**BOARD OF ZONING ADJUSTMENT  
STAFF REPORT****Date: November 2, 2015****CASE NUMBER**

6010

Cellular South Real Estate, Inc.

**LOCATION**3208 & 3210 Dauphin Island Parkway  
(West side of Dauphin Island Parkway 165'± North of  
Tallahassee Drive)**VARIANCE REQUEST****HEIGHT:** Height Variance to allow a 148' monopole telecommunications tower in a B-3, Community Business District.**SETBACK:** Setback Variance to allow the tower within 30' of the lease parcel line.**RESIDENTIAL BUFFER SEPARATION:** Residential Buffer Separation Variance to allow the tower within 60' of residentially zoned property.**ZONING ORDINANCE  
REQUIREMENT****HEIGHT:** The Zoning Ordinance limits structures to a 45' height in a B-3, Community Business District.**SETBACK:** The Zoning Ordinance requires telecommunications towers to be setback the height of the tower (148') from the lease parcel line.**RESIDENTIAL BUFFER SEPARATION:** The Zoning Ordinance requires a residential buffer separation of 200' or 150% of the height of the tower, whichever is greater (222').**ZONING**

# DETAIL SITE PLAN

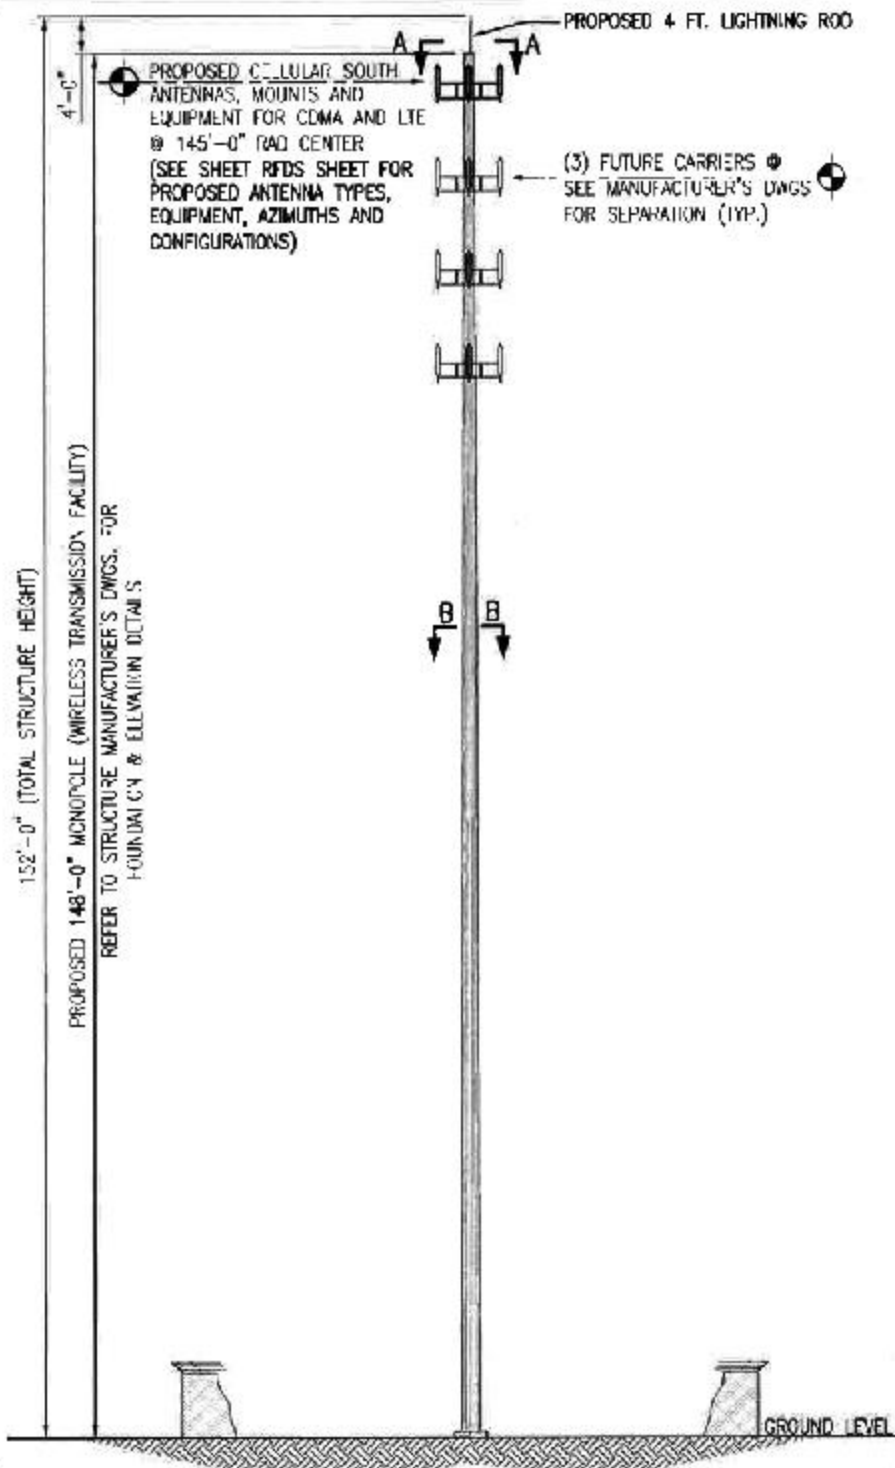
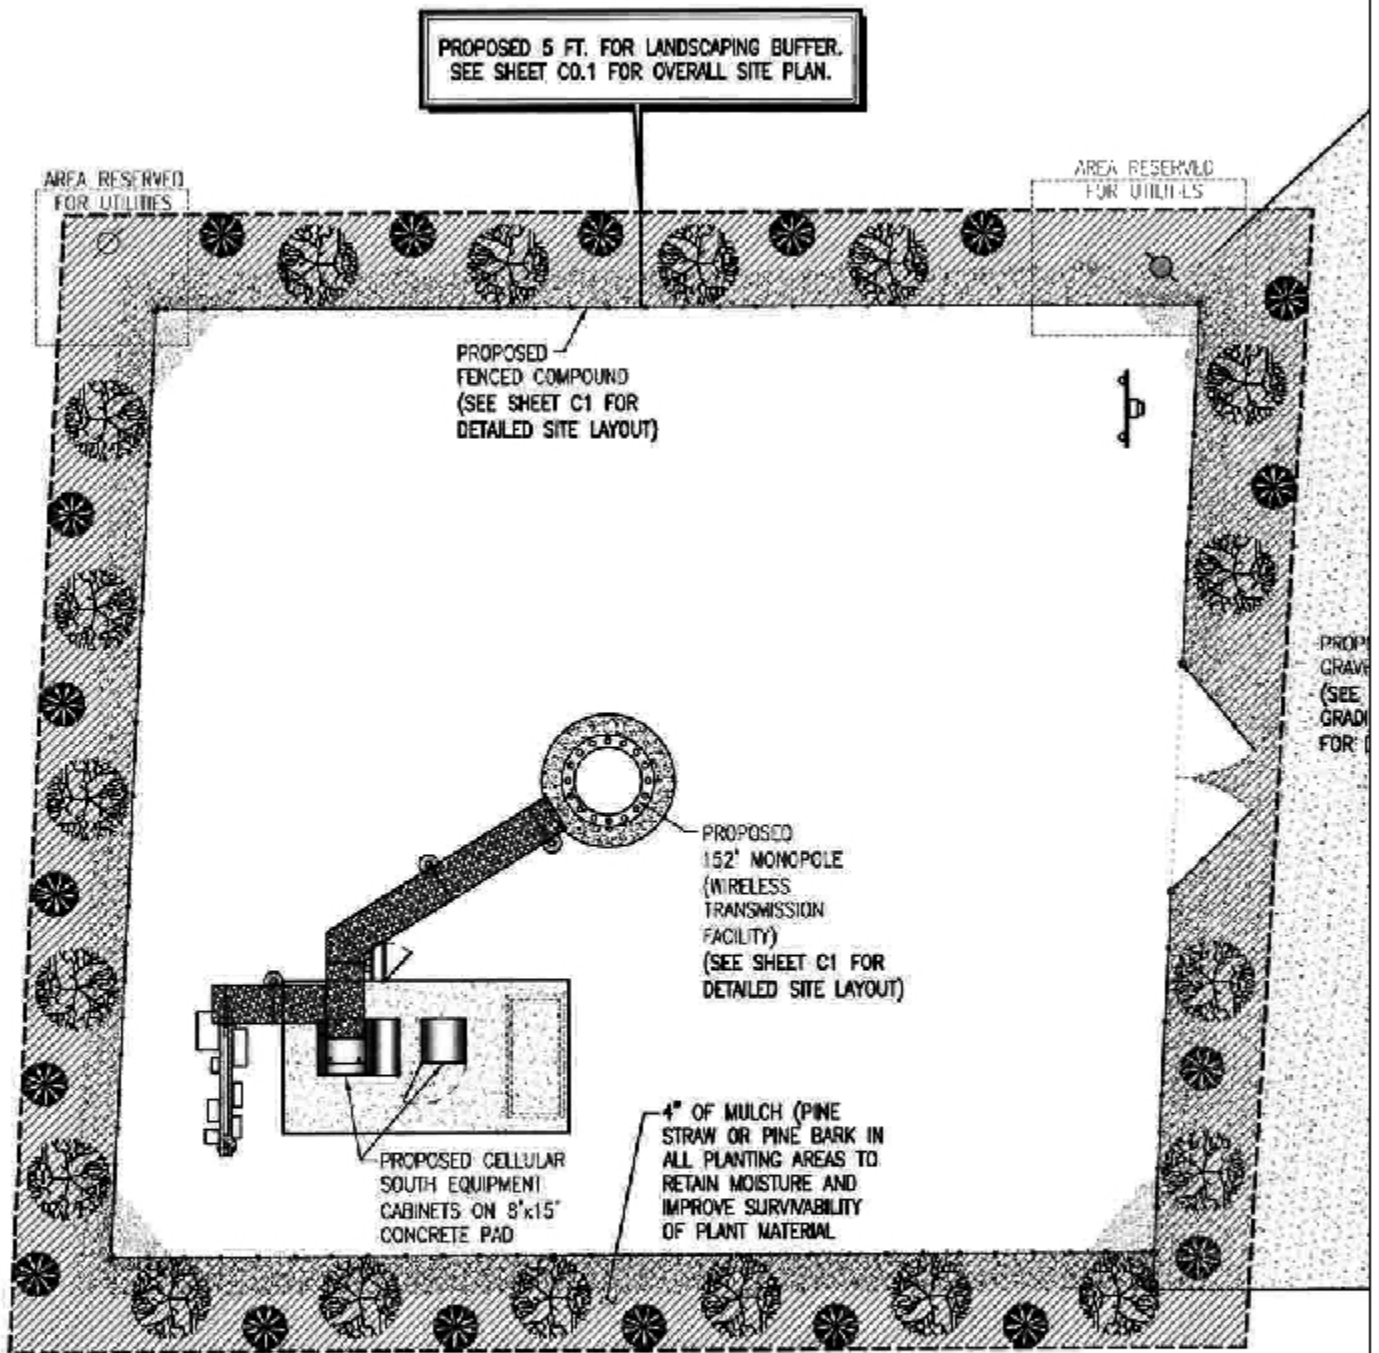
The site plan indicates the required 12' wide drive to the compound with an associated turnaround. However, they are proposed to be of gravel surface and not the required asphalt, concrete or approved alternative surface, or the variance requests can be heldover one month to allow for the additional request, with appropriate fees and notifications. As no Surface Variance request was applied for, the site plan should be revised to indicate the drive and turnaround to be paved in asphalt, concrete or an approved alternative paving surface.

A landscaping plan was submitted by the applicant indicating understory trees around the tower compound. As overstory trees are required, the landscaping plan should be revised to indicate overstory trees, to be coordinated with Urban Forestry, at a ratio of one tree per every 30 linear feet of compound perimeter.

The site plan indicates chain link fencing and gates around the tower compound. As the Zoning Ordinance requires an 8' high wooden privacy fence, the site plan should be revised to indicate wooden privacy fencing and gates 8' high around the tower compound.

- 1) the tower is limited to a monopole design with an over-all height of 152', including the lightning rod;
- 2) subject to the Planning Commission approval of the Planning Approval, Planned Unit Development, and two-lot Subdivision applications;
- 3) revision of the site plan to indicate the drive and turnaround paved with asphalt, concrete or an approved alternative paving surface;
- 4) revision of the site plan to indicate overstory trees, to be coordinated with Urban Forestry, at a ratio of one tree per every 30 linear feet of compound perimeter;
- 5) revision of the site plan to indicate wooden privacy fencing and gates 8' high around the tower compound; and
- 6) full compliance with all municipal codes and ordinances.

# SITE PLAN

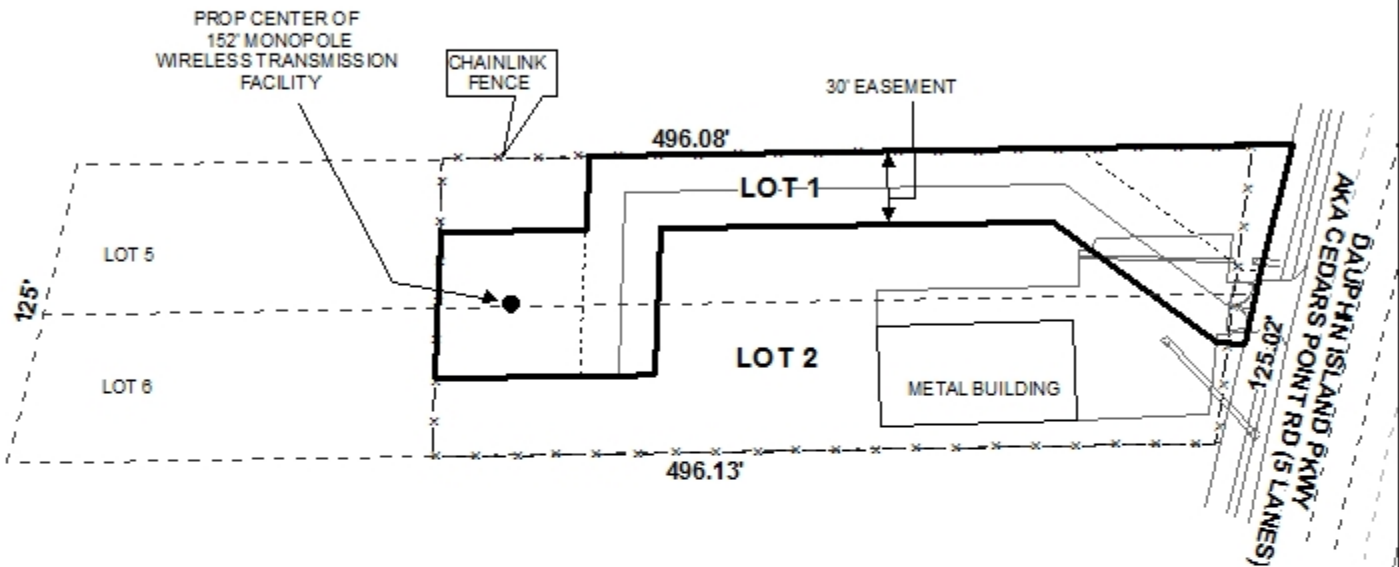
With regard to the Setback Variance request, the tower is proposed in the center of a 60' by 60' lease parcel (and proposed lot) which results in a 30' setback from the lease parcel lines to the North, West and South of the tower. As the site is limited in area by surrounding properties, a hardship is illustrated in meeting the tower height setback of 148' from the lease parcel lines, and technical data submitted by the applicant and the unavailability of other suitable sites, supports the selection of the subject site for the proposed tower. The same justification could be used for the Residential Buffer Separation request. The closest residentially zoned property is located 60' North of the proposed tower, but is used commercially as an office, and the next property North of that, also zoned residentially, is used as a church. To the South, the closest residentially-zoned property is approximately 250' distant. To the West, residentially zoned property is within approximately 190' of the proposed tower, with the closest dwelling within approximately 600'.
